The following changes in the tender documents are effective immediately. This addendum will form part of the contract documents.

**END OF ADDENDUM No. 2**

**WILLIAM HEAD INSTITUTION ELECTRICAL HIGH VOLTAGE UPGRADE (PHASE 2 OF 2)**

6 OUTDOOR UNIT SUBSTATION (US-1) GROUNDING DETAILS

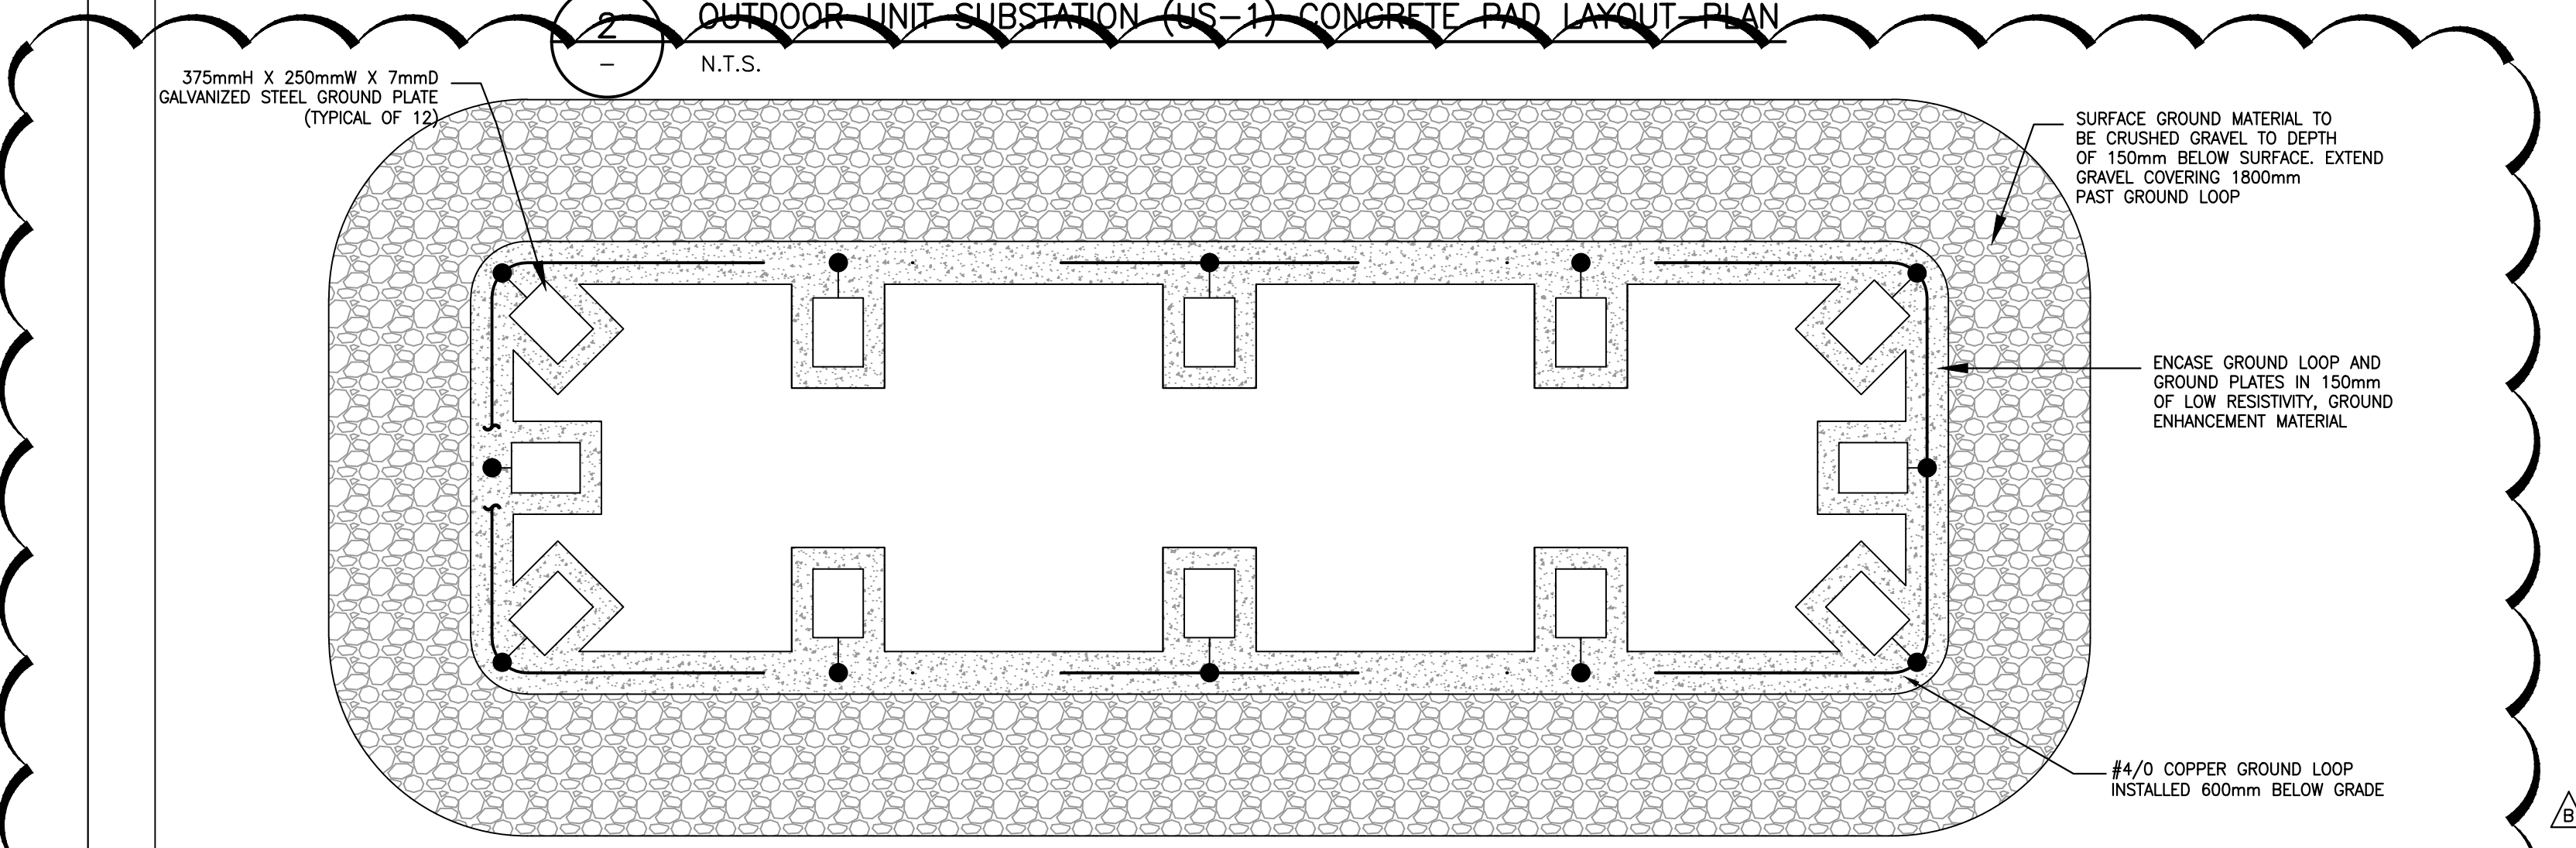
1. Add outline to single line diagram indicating items to be packaged in outdoor unit substation, US-1.
2. Add detail 6 for grounding details as noted.

Drawing title/Titre du dessin  
**BUILDING 103**  
**PARTIAL SITE AND FLOOR PLANS**

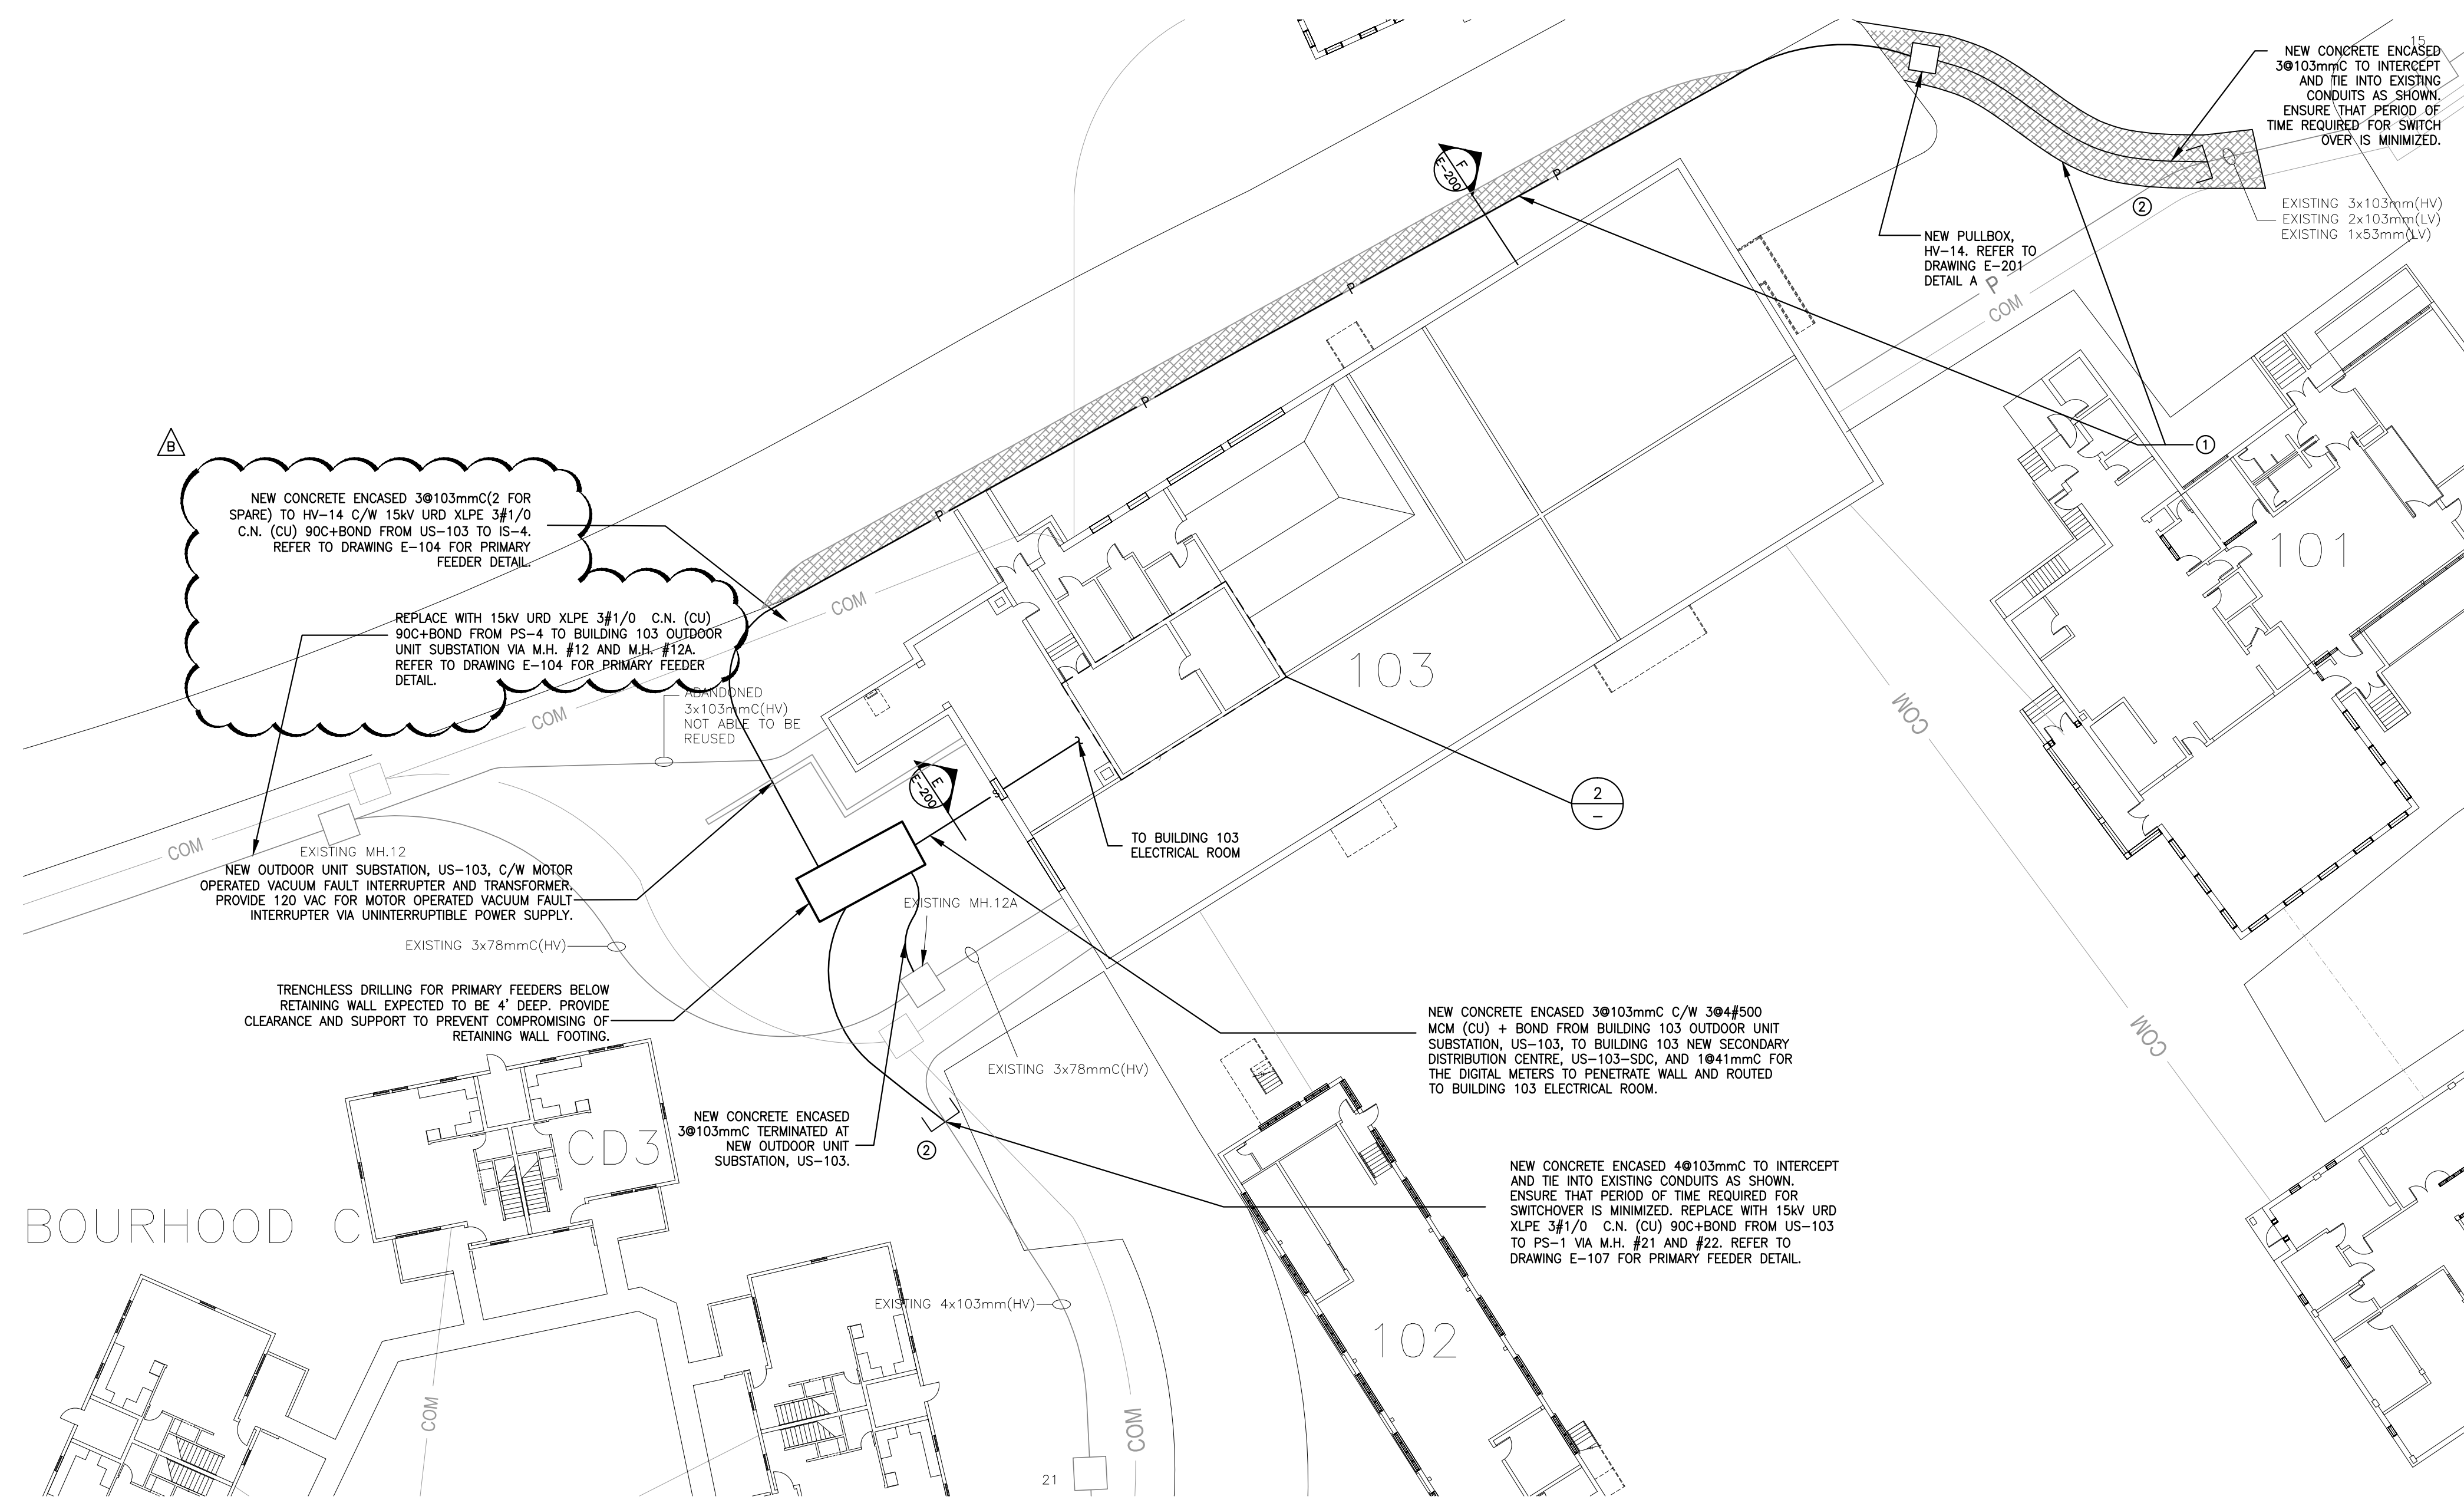
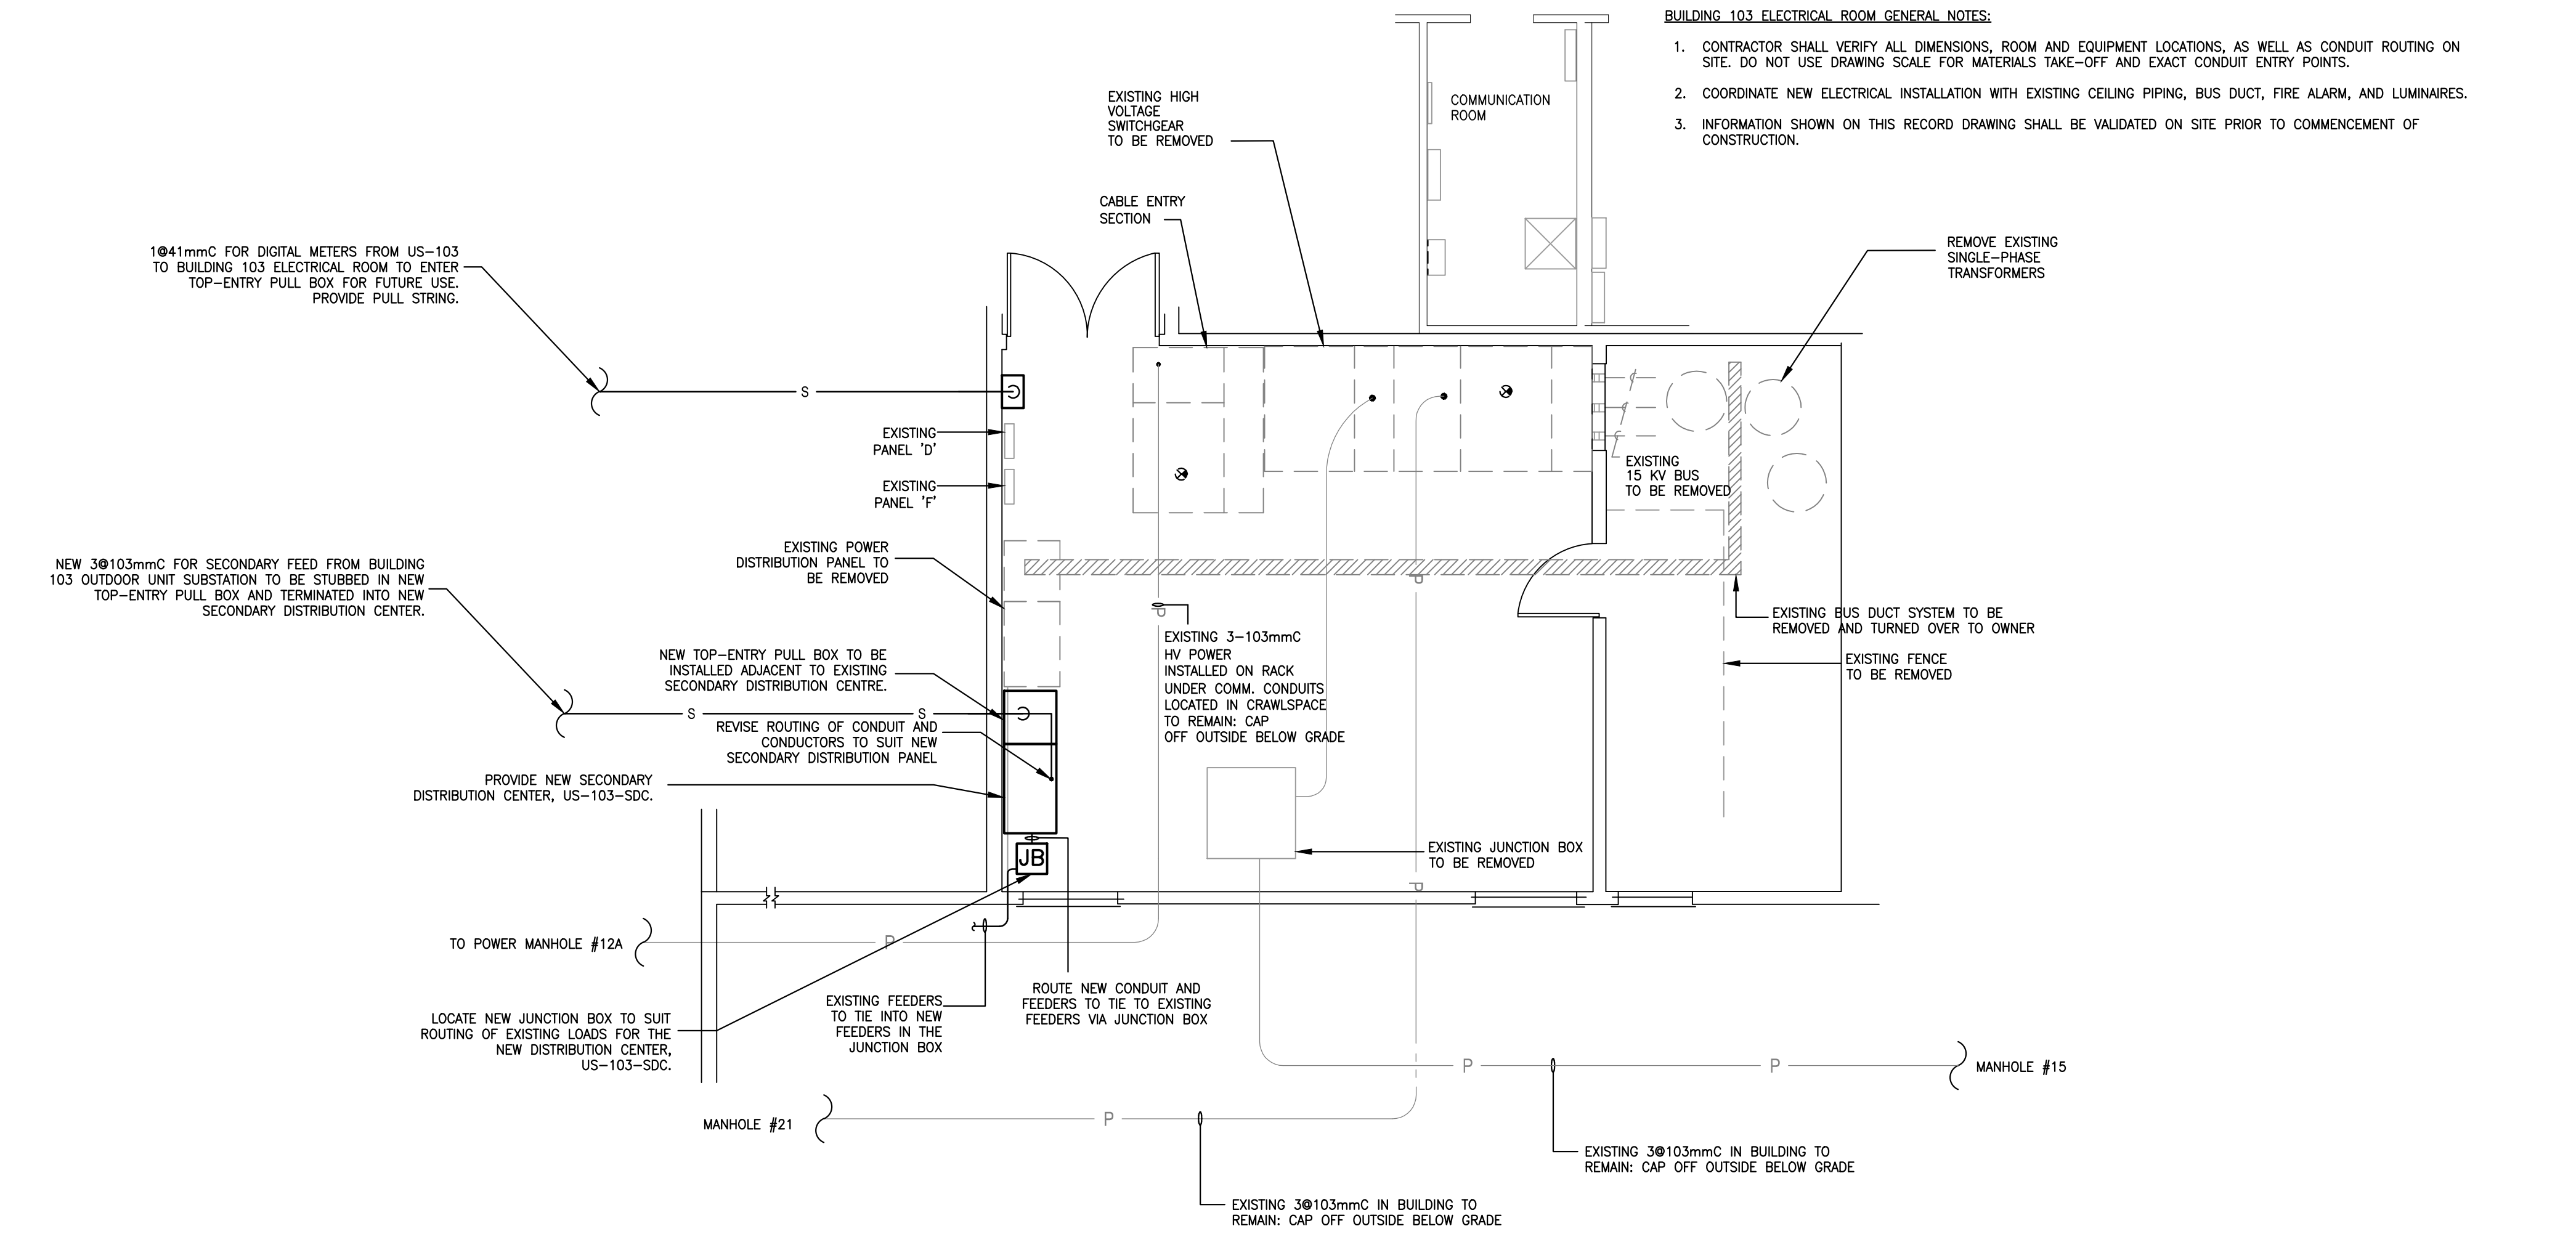
1. Revise reference to E-107 to be E-104 as noted.

**EXISTING ELECTRICAL ROOM NOTES:**  
 1. REFER TO DRAWING E-104 FOR ADDITIONAL DETAILS
